SOUTHWEST BIKEPATH CULVERT REPLACEMENT AT WAITE CIRCLE - 2019

CITY OF MADISON, WI

CITY PROJECT NO. 8466

ADDENDUM 1
8/29/19
CHANGED ENTIRE
DRAWING

DRAWING NUMBER
C-3
 SHEET NUMBER
 8 OF 25

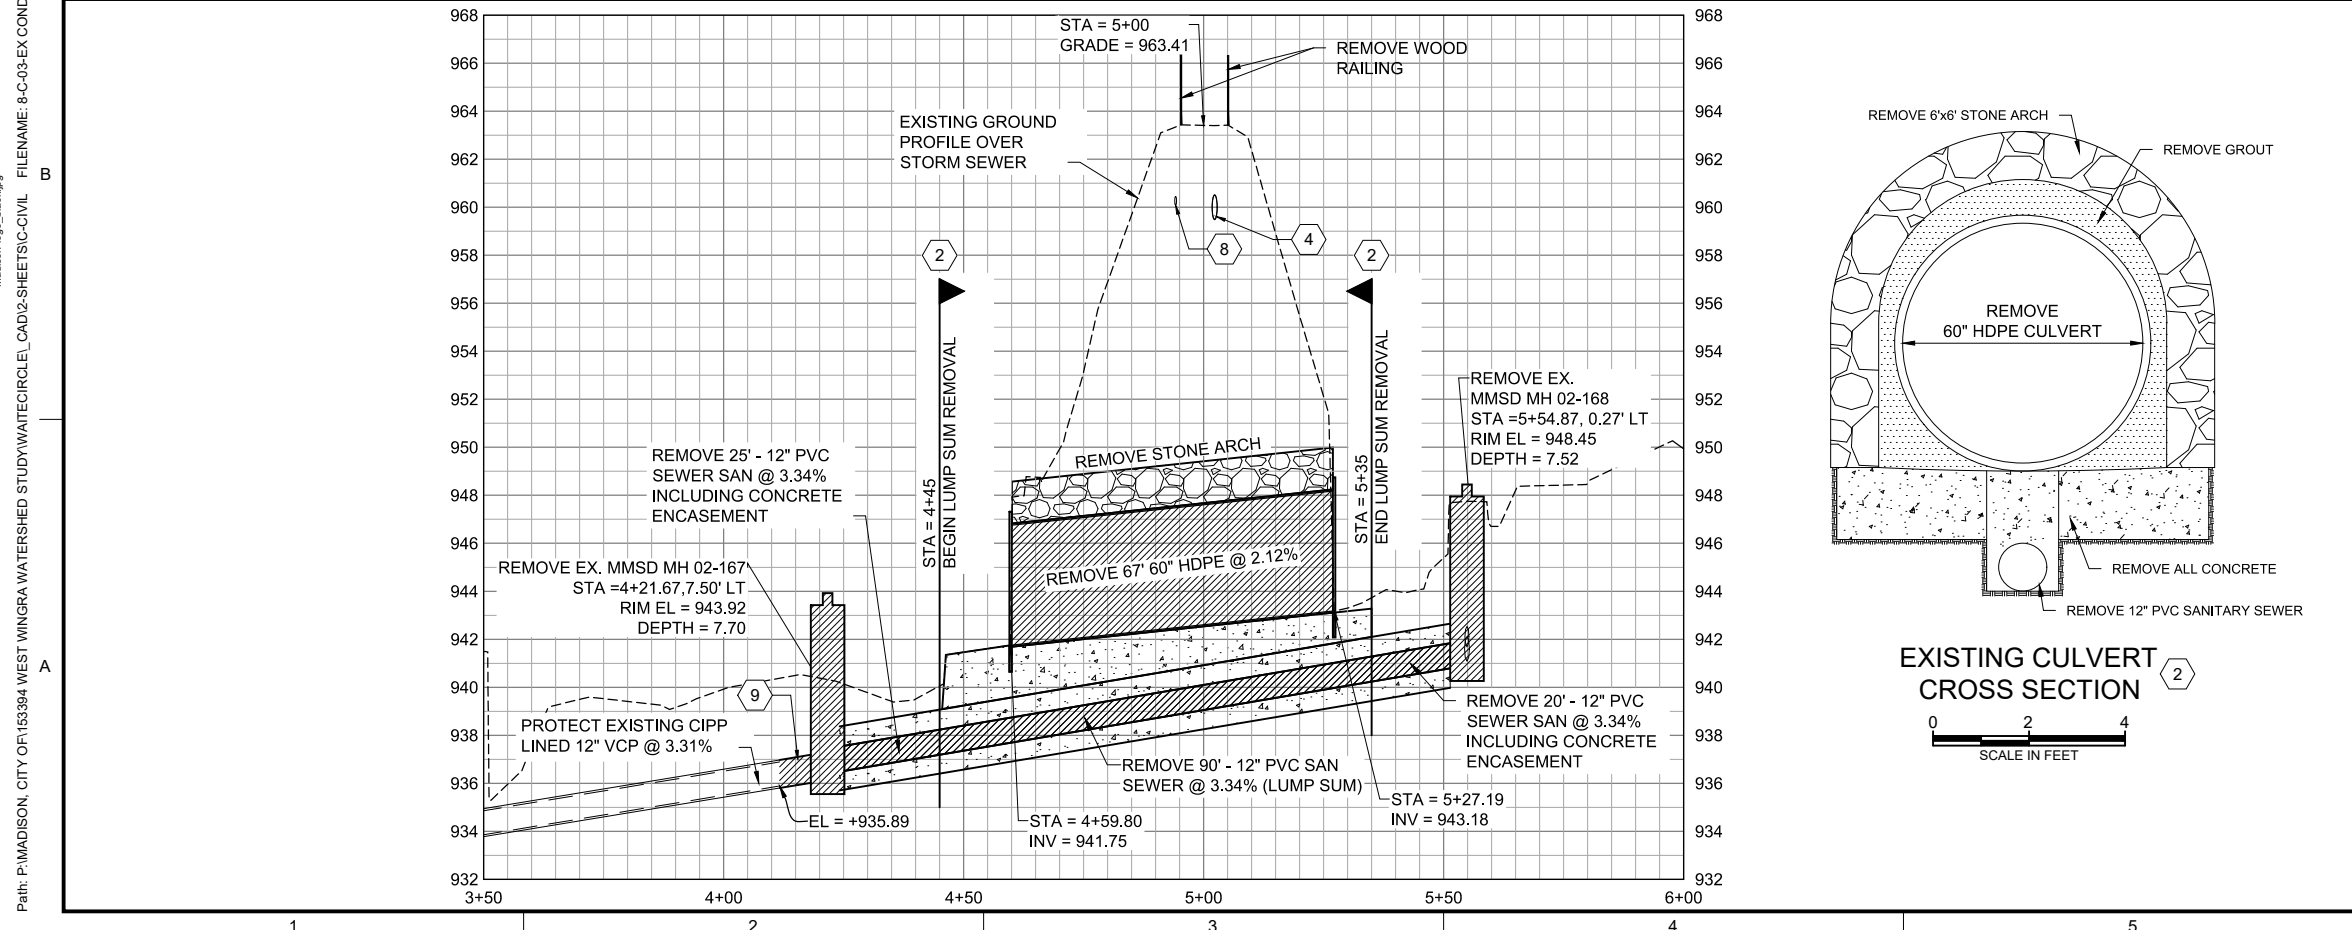
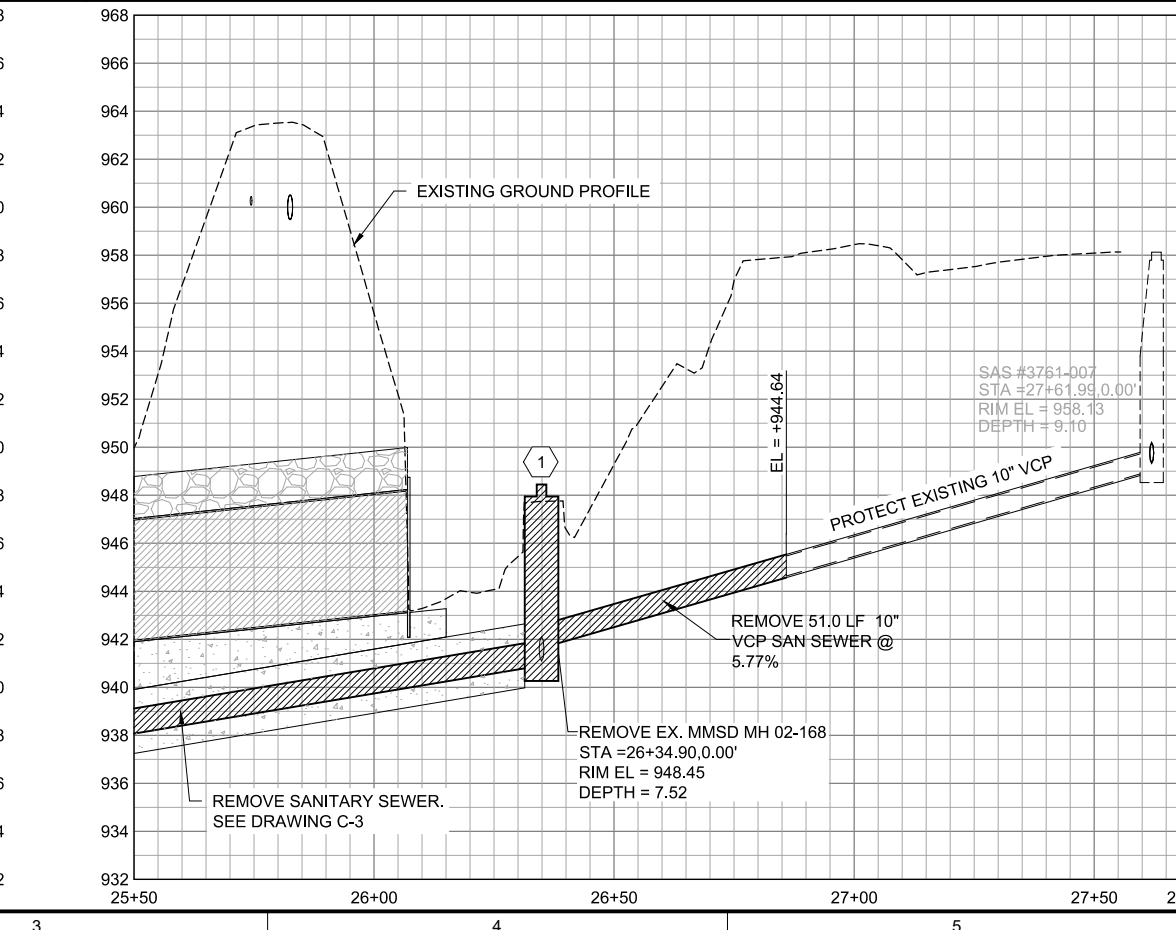
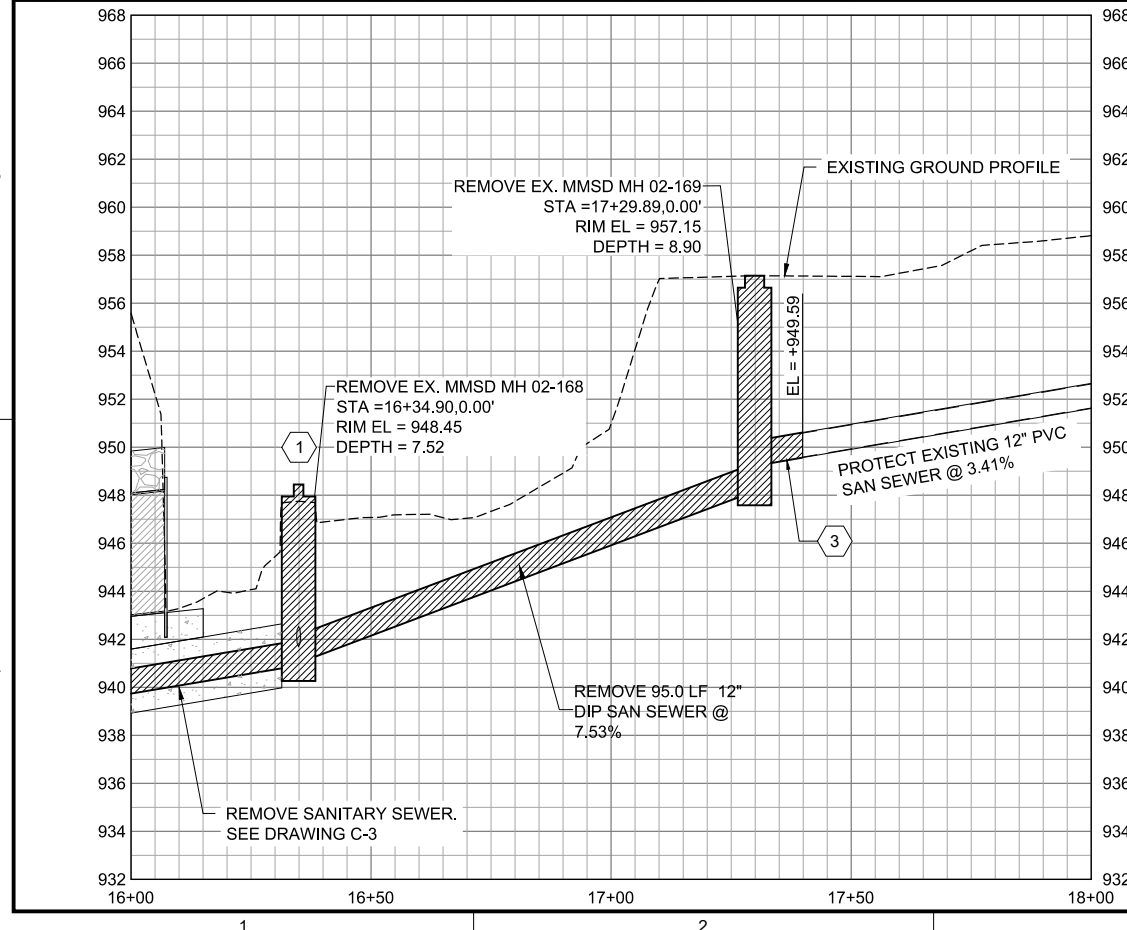
**ADDENDUM 1
 CHANGED
 ENTIRE
 DRAWING**

DRAWING NUMBER
C-4
 SHEET NUMBER
 9 OF 25

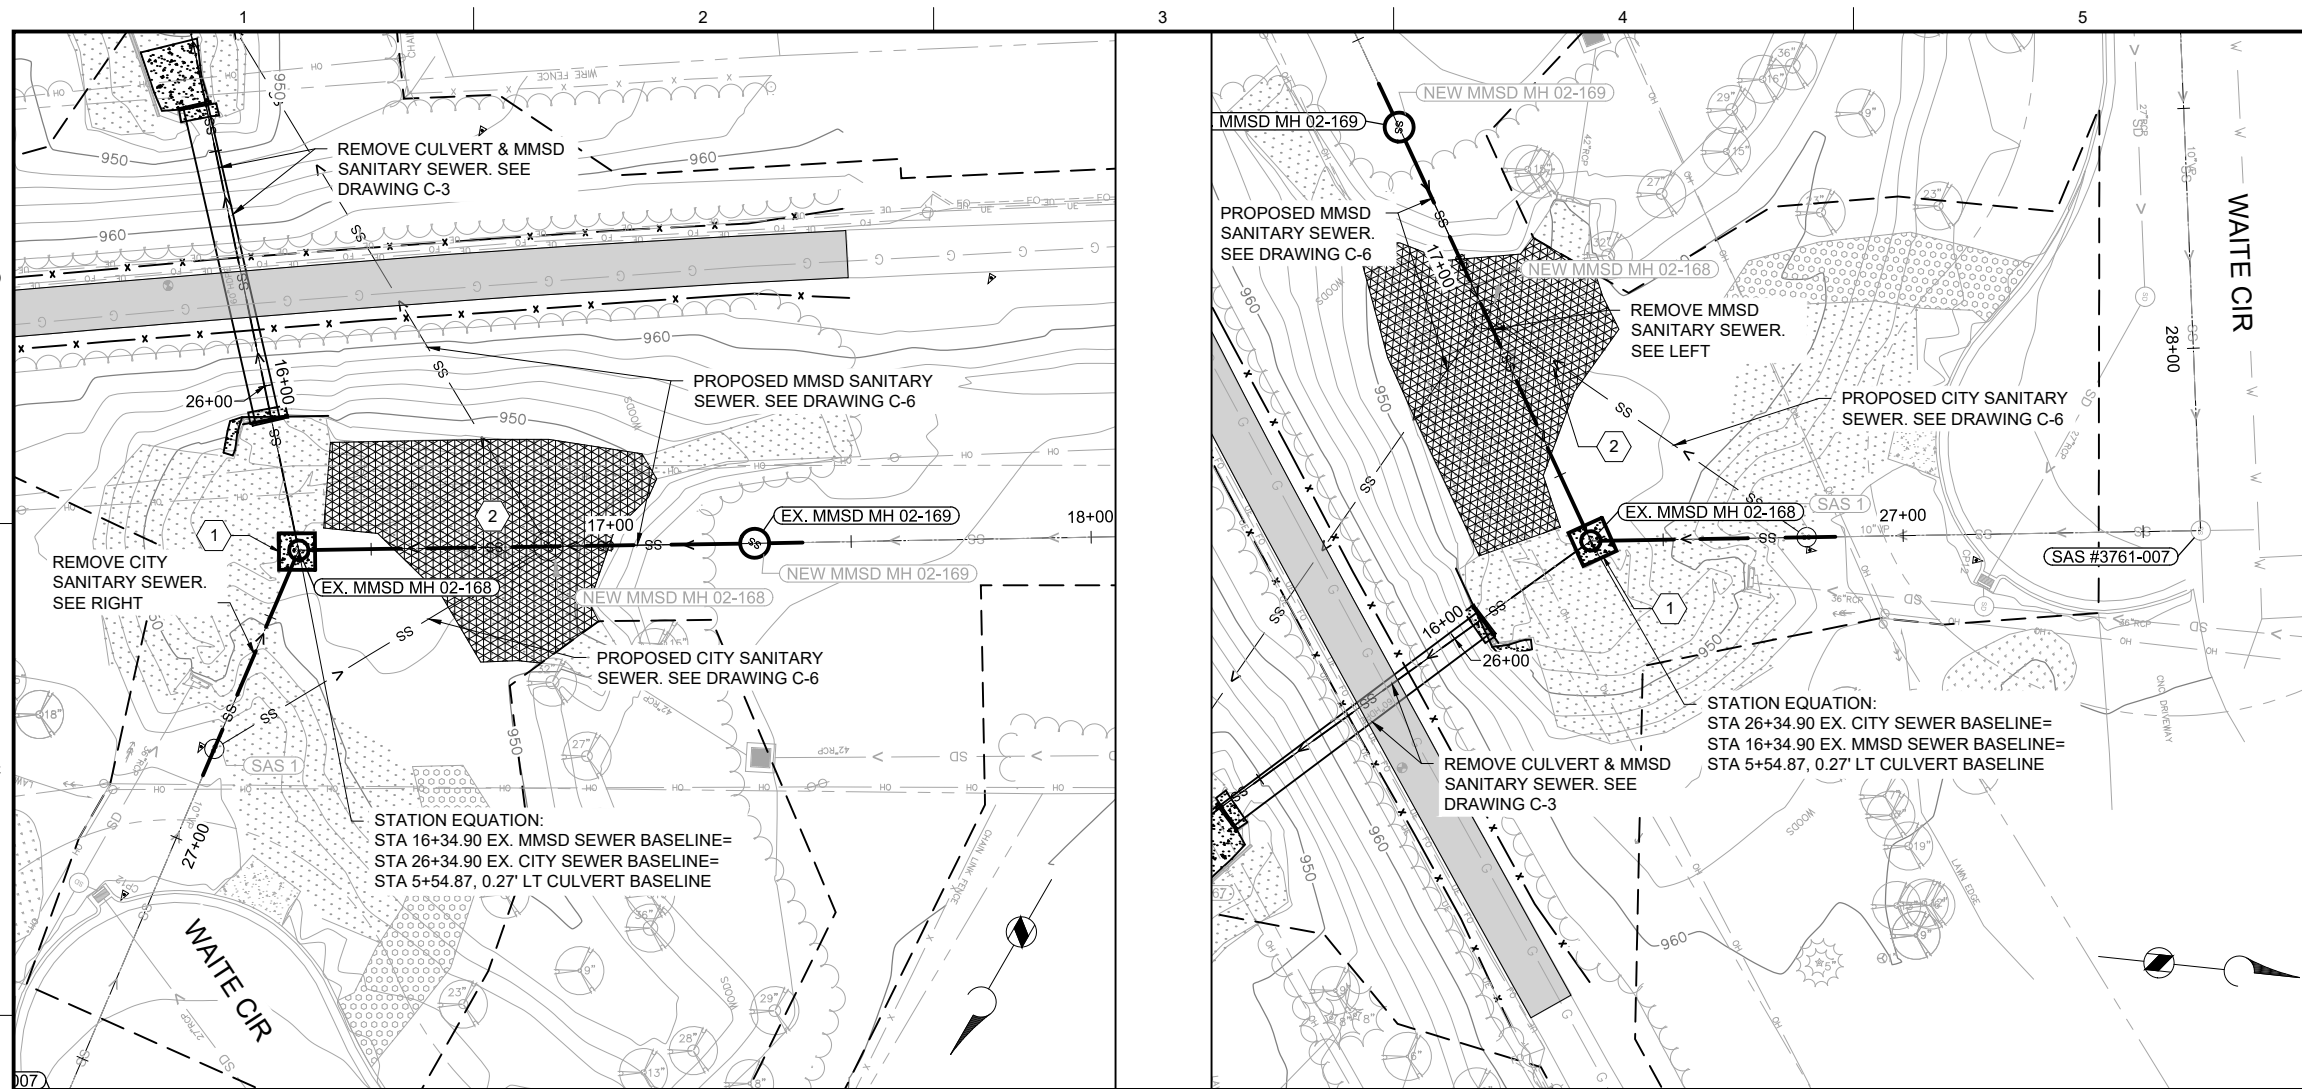
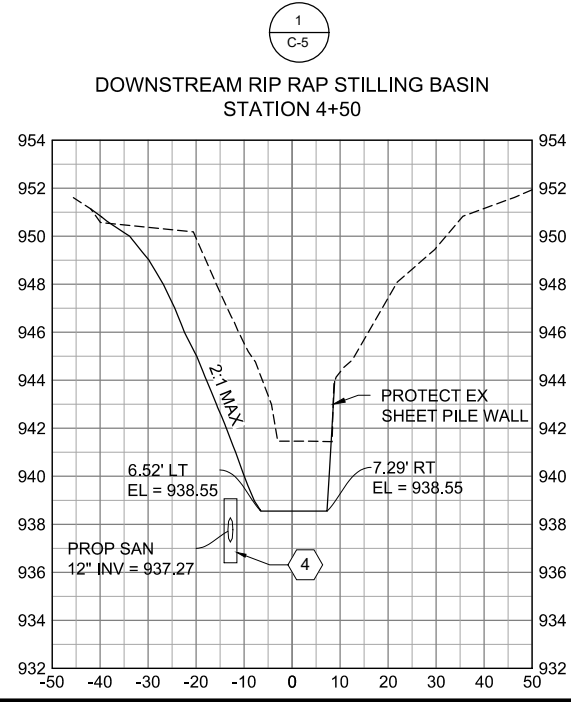
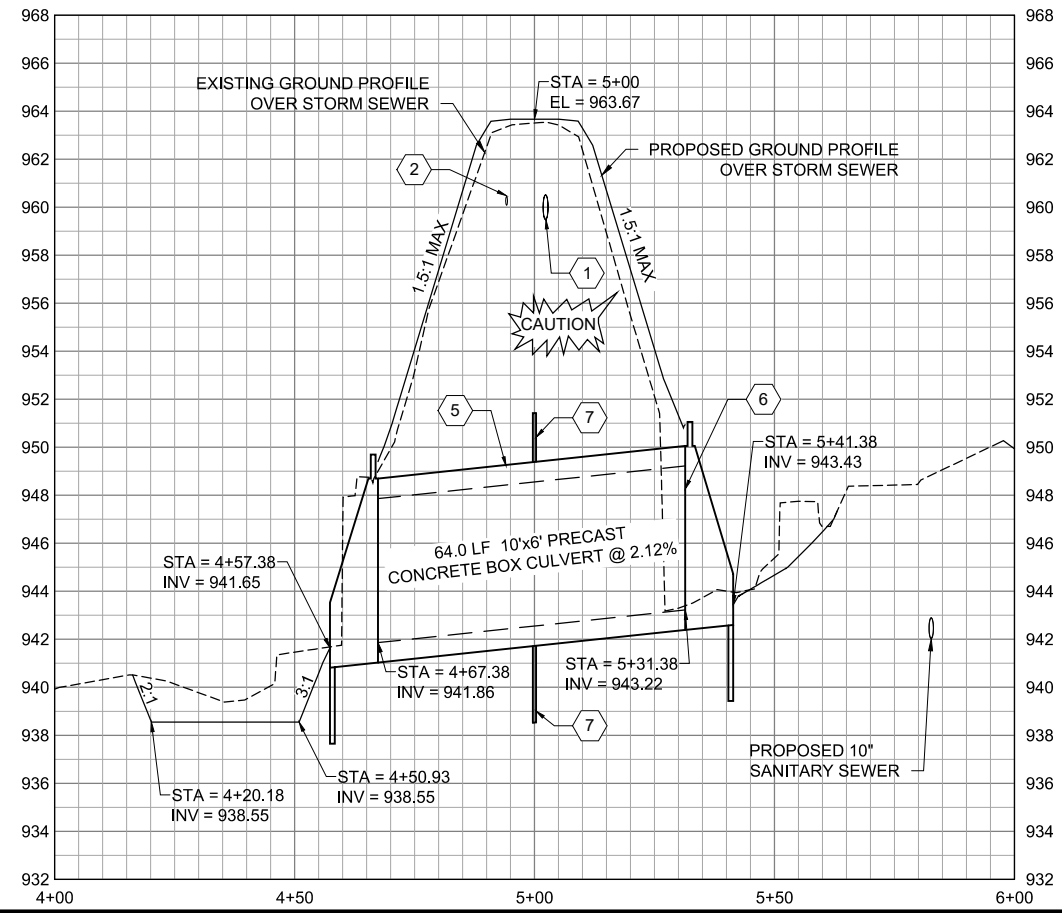
**ADDENDUM 1
CHANGED
ENTIRE
DRAWING**
